# IBC - Structural

2022 GROUP B PUBLIC COMMENT AGENDA

## 2022 Public Comment Agenda

Figure 1: Direct-Fastened, Non-Cleated Eave Edge System

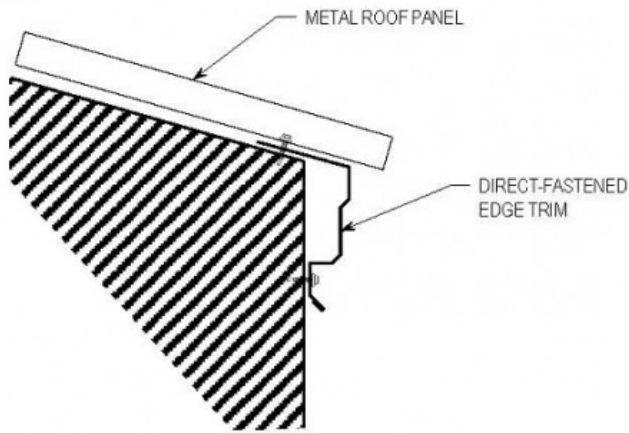
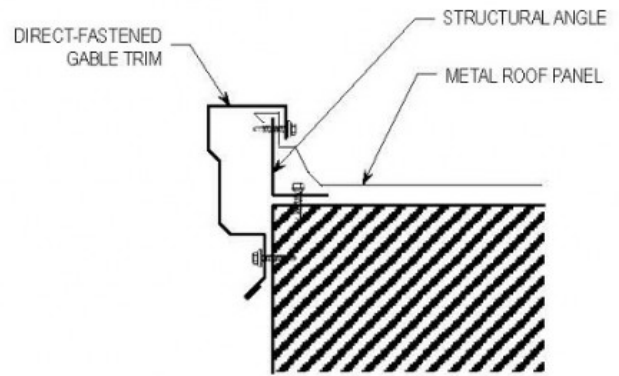
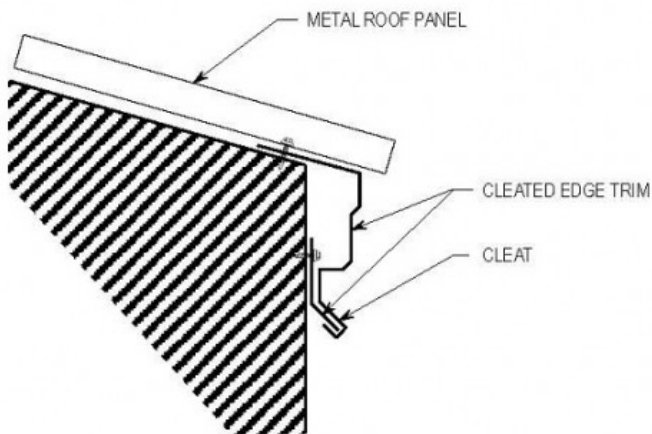
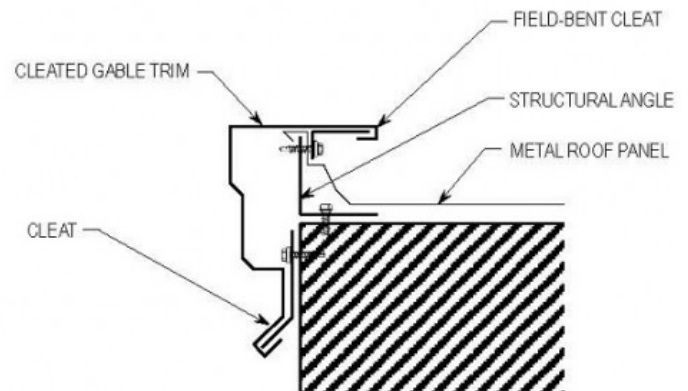
- 1) Where a multi-piece edge trim assembly incorporating cleats deformed enough to disengage the cleat.
- 2) Where the metal edge trim assembly was fastened to a non-metal substrate such as wood or masonry, leaving to question the appropriateness of the fastener used since it would often not be provided by the edge system manufacturer for non-metal substrates.

The exception in Section 1504.7 recognizes that neither of the two conditions listed applies to non-cleated, single-piece edge systems attached to structural metal roof or wall panels and framing, provided the fastening is appropriately designed in accordance with the relevant design standards. (i.e., the fastener and substrate material requirements and fastener spacing criteria of these standards are met.) These standards are AISI S100 for cold-formed steel and AA ADM for aluminum. See Figures 1 through 4 in the attachment or at <<https://tinyurl.com/2p8msj2t>>, which visually differentiate these conditions.

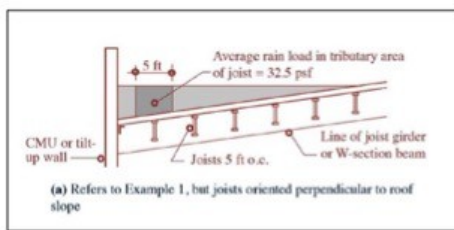
**Figure 1** (left) shows the roof collapse, and **Figure 1** (right) shows the structural orientation.

Figure C3105.5.1. ASCE 7 wind MRI versus reliability index (McAllister, Wang, and Ellingwood 2018).

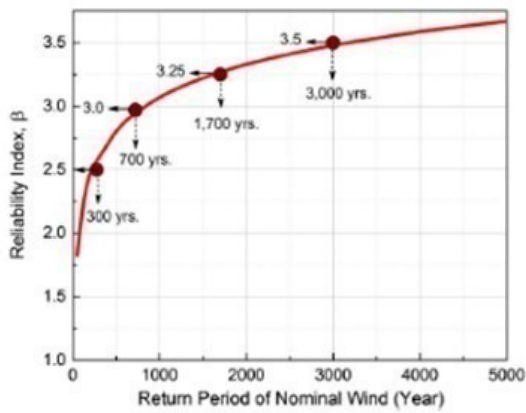
ASCE 7-16 wind hazard maps were updated to confirm the risk-based mean recurrence interval (MRI) for RC I to III and to establish a risk-based MRI for RC IV (McAllister, Wang, and Ellingwood 2018). The updated wind maps are based on a fully coupled reliability analysis that considered the hazard and structural resistance. The results for the recommended MRI for the target reliabilities are shown in Figure 3105.5.2.

Until further analyses can be conducted, a 10-yr service life and a wind speed factor of 0.9 is deemed to provide a reasonable level of reliability, given the ability to evacuate or modify temporary structures for strong wind events.
